3.12 CASK HANDLING

Re: Turkey Point Units 3 & 4
Docket Nos. 50-250, 50-251
Fuel Assembly Decay Time

SAFETY ANALYSIS: FUEL SHIPMENT <120 DAYS

FIG. 2.29. Decay power as function of time after shutdown

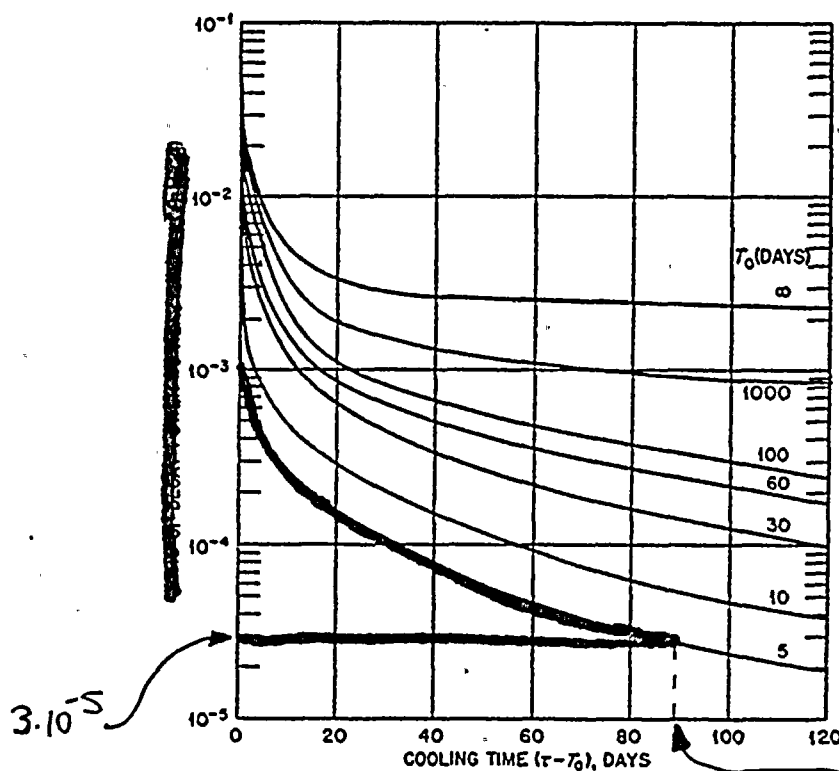
CORE DECAY HEAT CALCULATION

$$\frac{P}{22} = 6.1 \cdot 10^{-3} \left[(87 - 3)^{-0.2} - 87^{-0.2} \right] *1$$

$$P = 0.387 \cdot 10^{-3} \quad MW_T = .387 \text{ KW}_T \text{ (Total core)} *2$$

∴ No problem with cask requirement of < 2.5 kw per assembly
